# TOWN OF CORTLANDT PLANNING BOARD

**MEETING AGENDA.....PLANNING BOARD  
TOWN OF CORTLANDT  
6:30 THURSDAY EVENING\*  
OCTOBER 7, 2025**

**PB 2023-5** a. Letter dated September 29, 2025 from David Steinmetz, Esq. requesting the 7<sup>th</sup>, 90-day time extension of Final Plat Approval for the Evergreen Subdivision located at 2003 Crompond Road.

STORM PROFILE: ES - 1

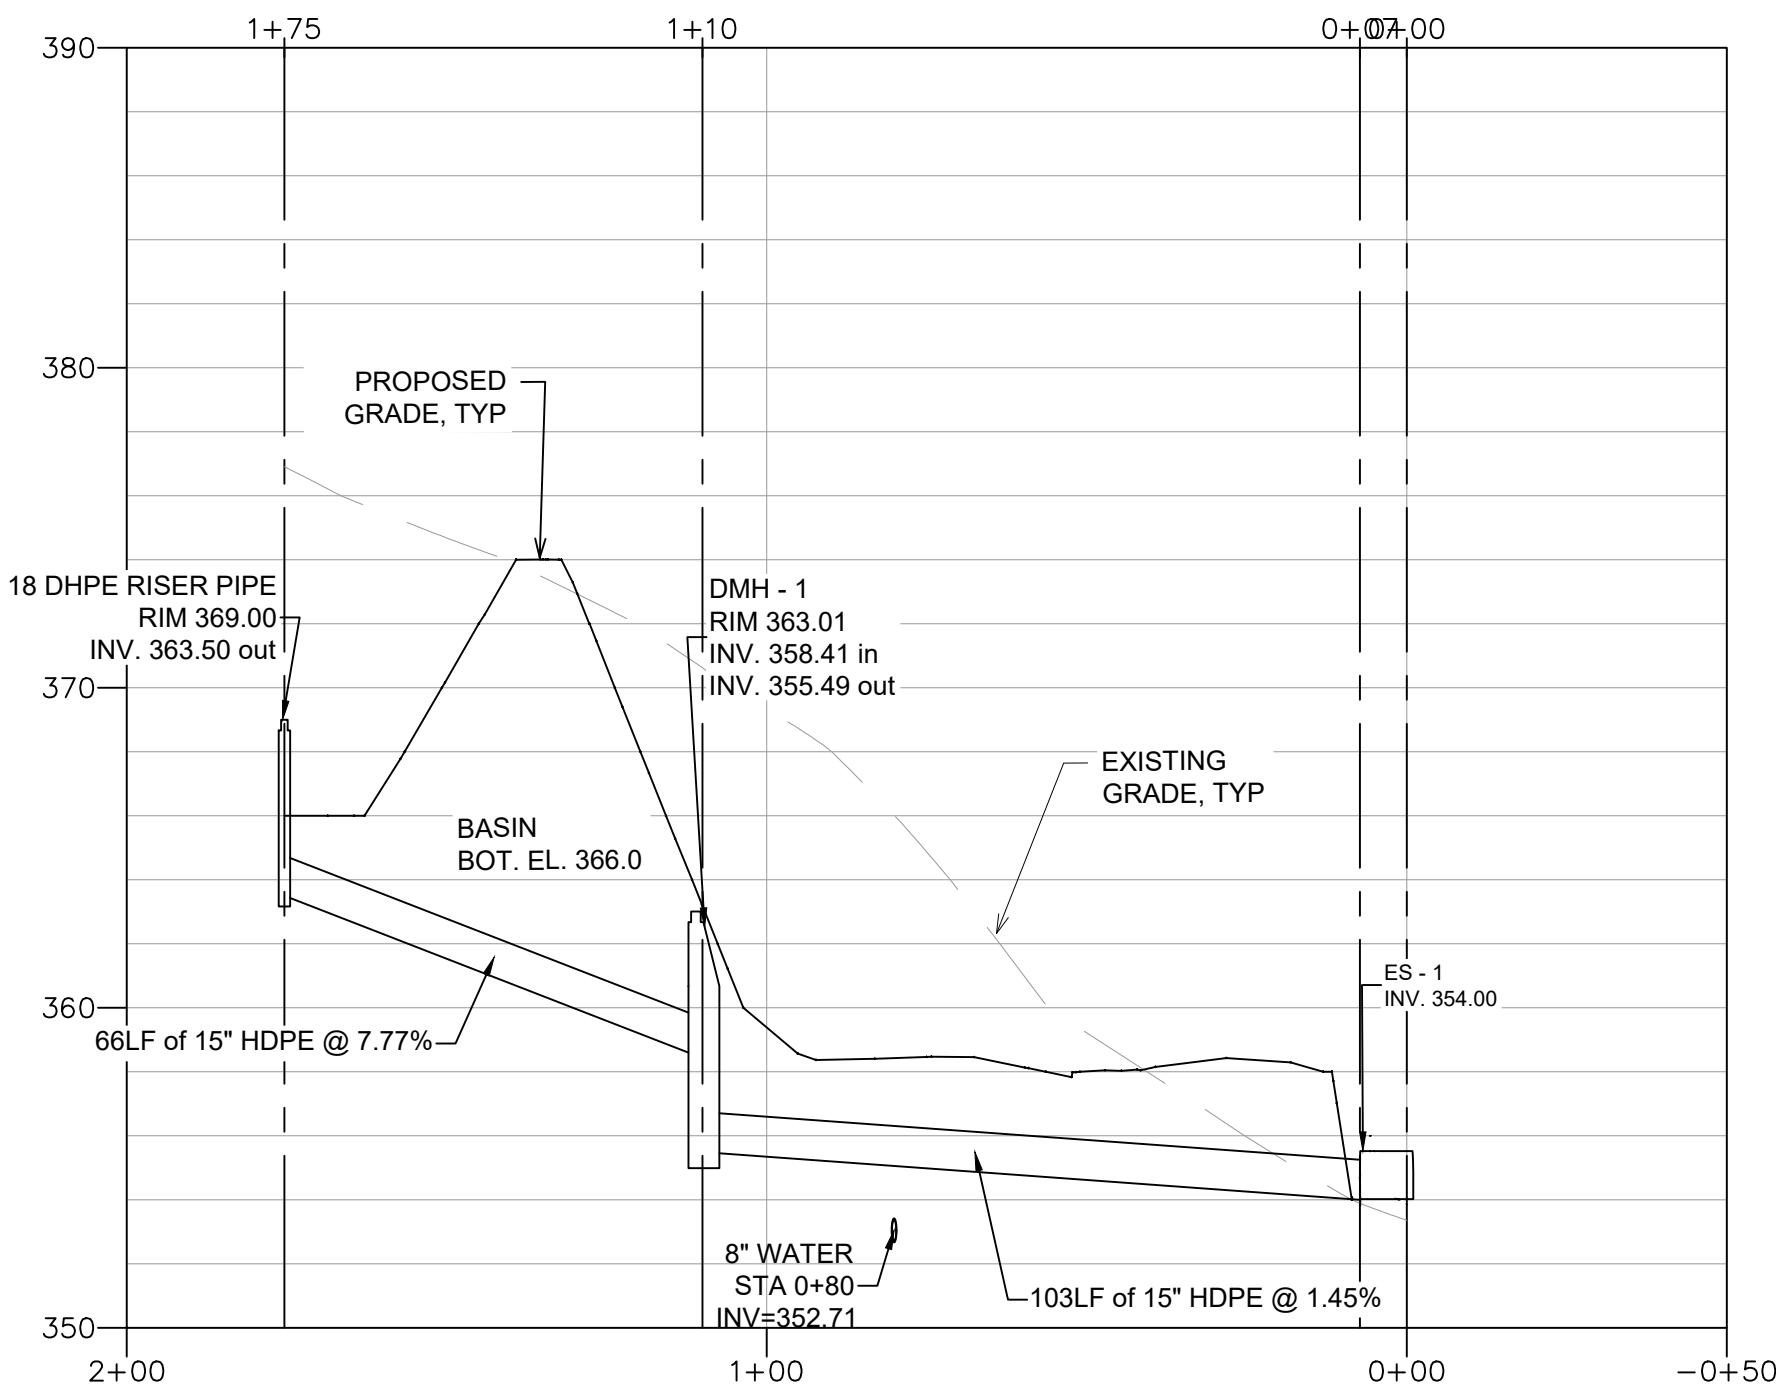
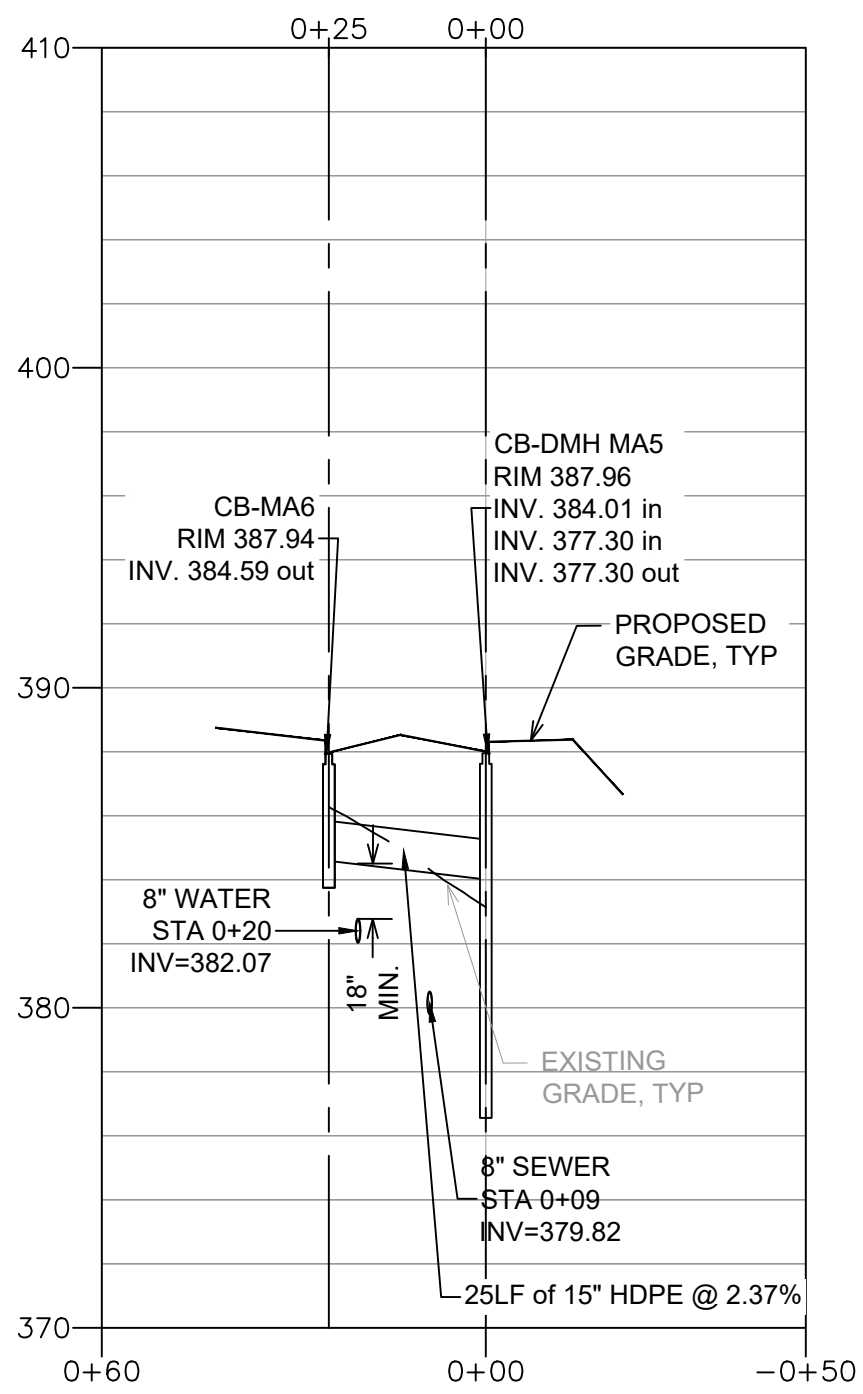
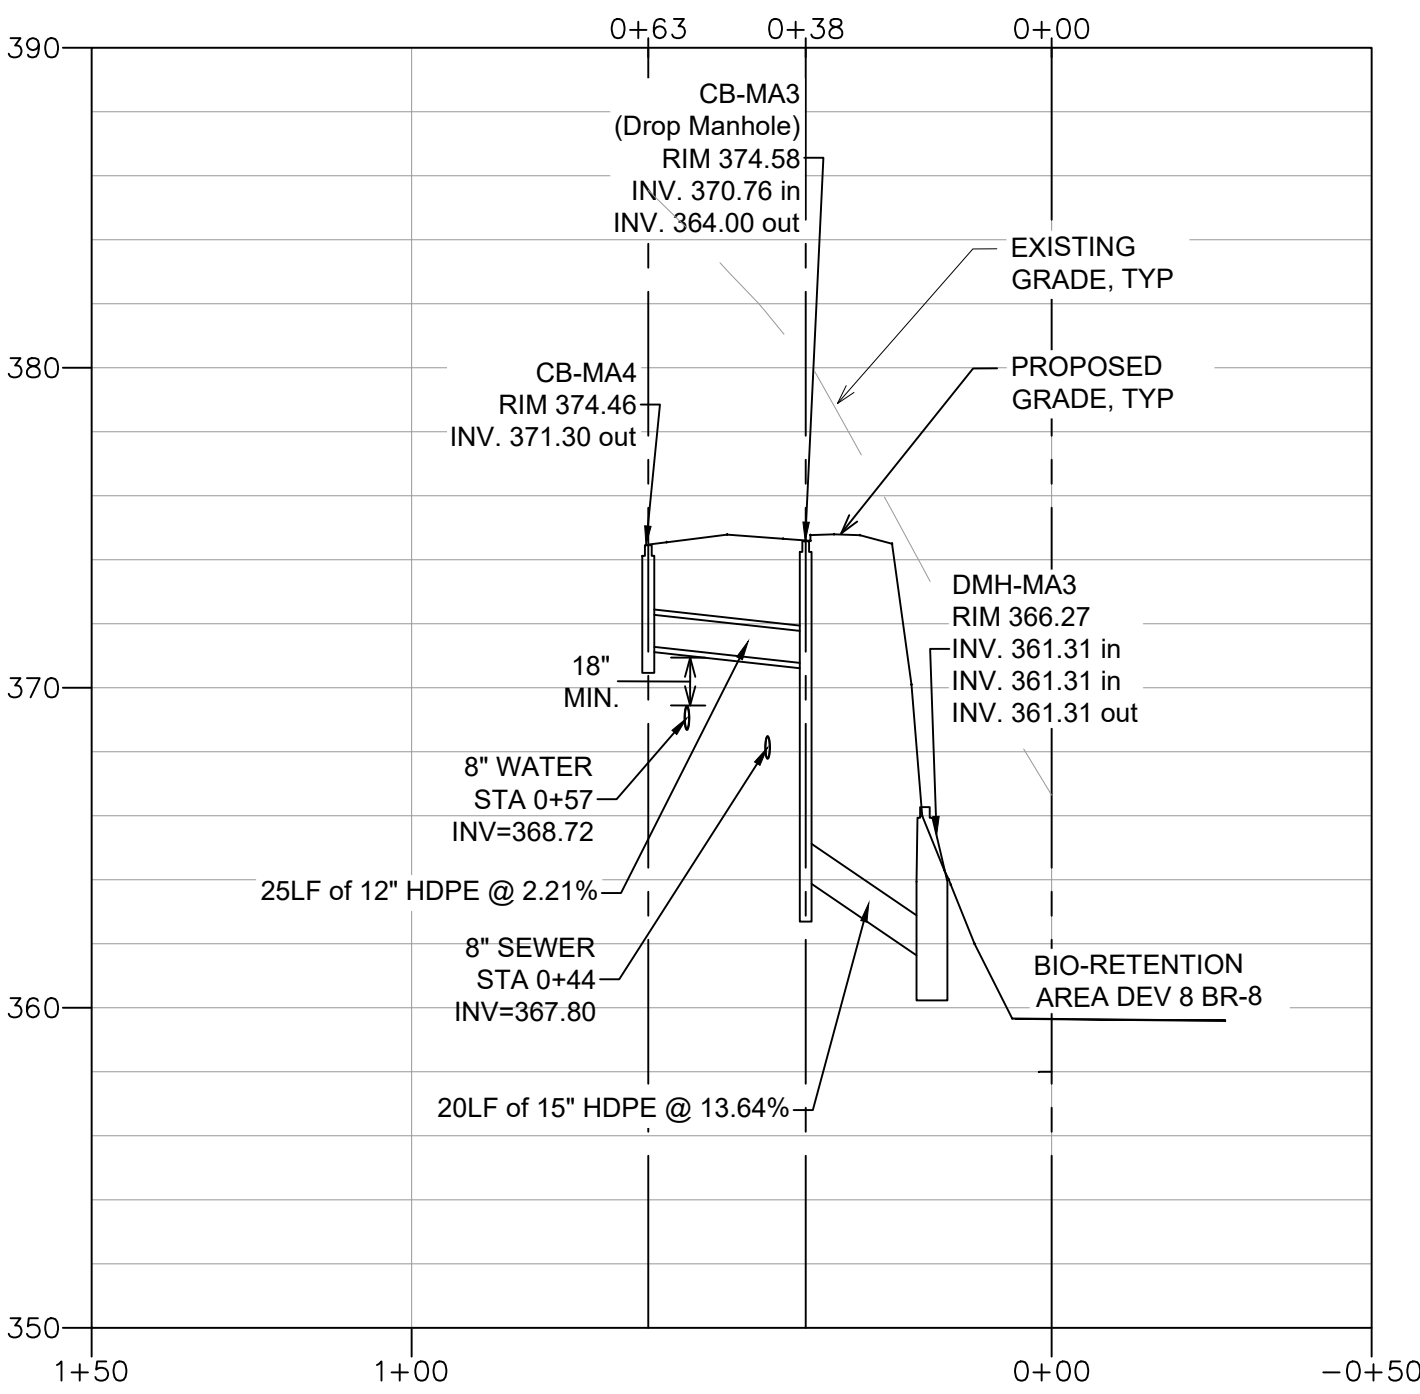
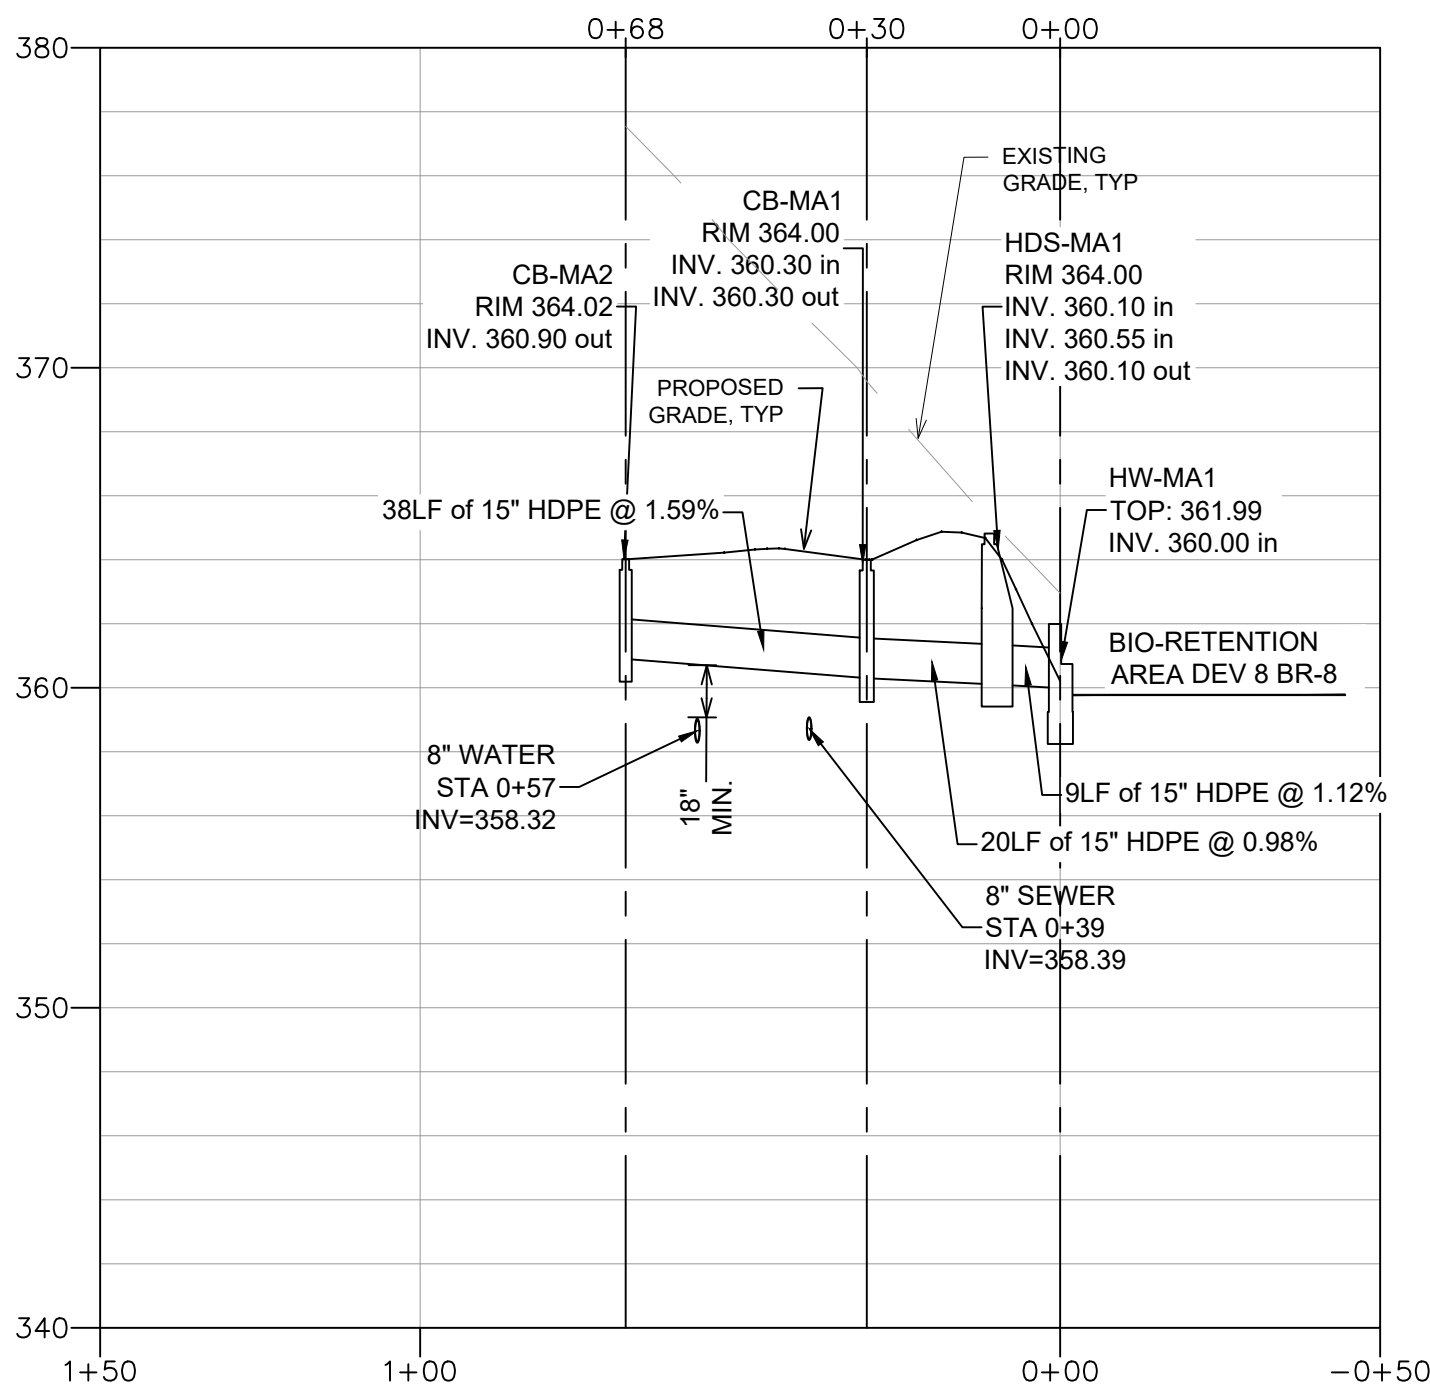
49.     *Comment:*         *SP-3.1 - Provide stationing of all catch basins and drainage manholes.*  
          *Response:*       Stationing of all drainage structures is now shown on the profiles.

50.     *Comment:*         *SP-3.1- Provide stationing and invert elevations of all crossings.*  
          *Response:*       Stationing and invert elevations of all crossings are now shown on the  
profiles.

51.     *Comment:*         *SP-3.1 – Provide a slope for the concrete pipe at the end of profile HW-MA1*  
          *Response:*       The pipe slope has been added.

52.     *Comment:*         *SP-3.1 – Provide anti seep collars on the pipe between CB-MA5 and DMH-*  
                              *MA4*  
          *Response:*       A concrete anti-seep collar detail has been added to Drawing SP-4.1.

53.     **Comment:**     *SP-3.1 – The invert out of CB-MA5 is higher than the lowest inv. in.*  
          **Response:**    The invert out has been revised as required.

54.     **Comment:**     *SP-3.1 – The profile shows downstream pipe sizes smaller than upstream pipes. This design is not acceptable and should be revised.*

55.     **Comment:**     *SP-3.1 – CB-MA8 is shown to have two outlets. One is higher than the invert into this structure.*  
          **Response:**    The outlet configuration at CB-MA8 has been revised. The structure now shows a single outlet at the correct invert elevation, consistent with the incoming pipe. The profiles and drainage schedules have been updated accordingly.

56.     **Comment:**     *SP-3.1 – The bioretention areas should be designed offline with an upstream bypass to prevent excessive flows from entering the practice.*
